PLC 7 (Logica)

NHS 750

PLACA lógica PCL7

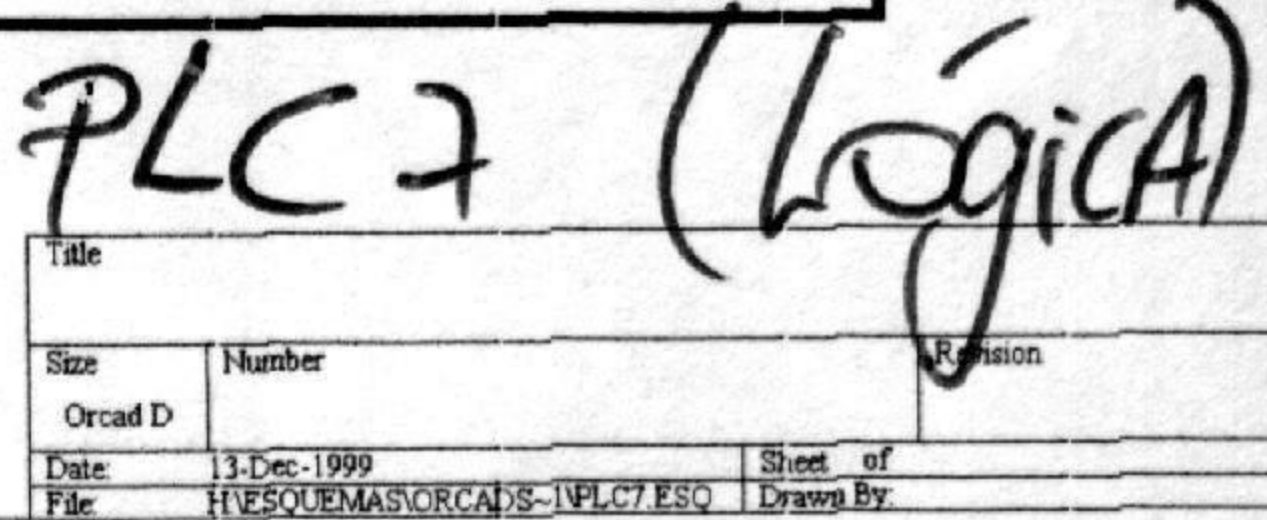
REV. 3 P/ REV. 04	VALOR:
ALTERACAO DE	
CAP/R37 - 22nF P/10nF	
INCLUSAO	
CAP/R40 - 10nF/250V	
R62 - 470K	
REV. 04 P/ REV. 05	
C9 - 10nF P/ 22nF	
R85 - 1K2 P/ 1K5	
R68 - 270K P/ 180K	
R2 - 120K P/ 82K	
R1 - 4K7 P/ 1K	
REV. 05 P/ REV. 06	
R78 - 33K P/ 18K	
REV. 06 P/ REV. 07	
R78 - 18K P/ 22K	
R18 - 10K P/ 12K	
REV. 07 P/ REV. 07	
D5,D6 - 1N4148 P/ NONE

R20 e R22 são iguais e ajustão a tensão de saída do inversor;
Provavelmente o valor original será 180K, recomendado 47K,
(pessoalmente consegui ajuste bom com 150K)
